Reference: Hanford Waste Vitrification Plant
DOE Contract DE-AC06-86RL10838
Fluor Contract 8457

NUMBER	REV	DATE	TITLE
DCN-000023	-----	04/01/93	DCN TITLE: "HOLD" SCATTER MITIGATION CHANGE REQUEST (CANISTER STORAGE BUILDING E350)

HANFORD WASTE VITRIFICATION PLANT DESIGN CHANGE NOTICE (DCN)	DCN NO. <u>000023</u>	SHEET <u>1</u> OF <u>3</u>
	DCN TITLE <u>"HOLD" SCATTER MITIGATION CHANGE REQUEST (CANISTER STORAGE BUILDING E350)</u>	
	ORIGINATOR <u>R. GRUBER / M.V.</u>	DATE <u>03/15/93</u>

DCN NO. 0023
HOLD
HWVP-FD 260

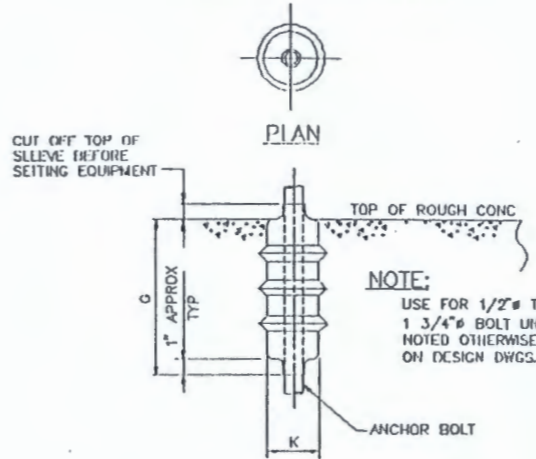
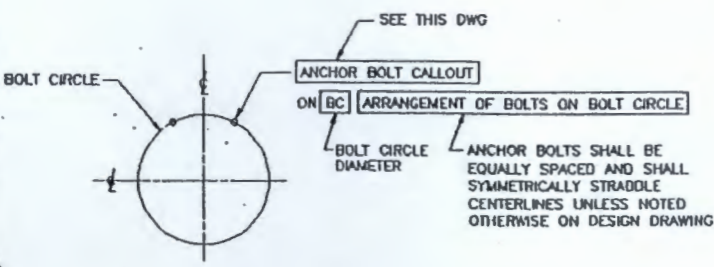
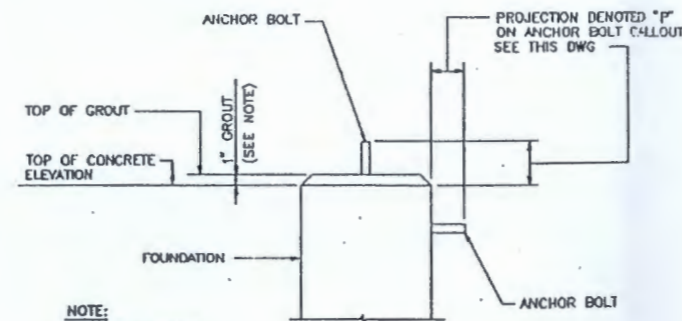
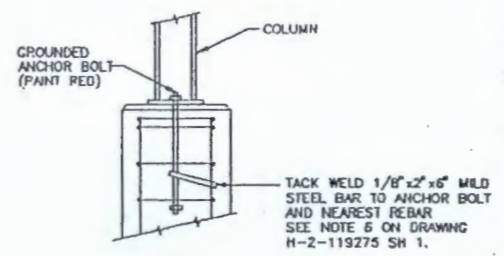
All of the above documents are on "HOLD" as per the attached example.
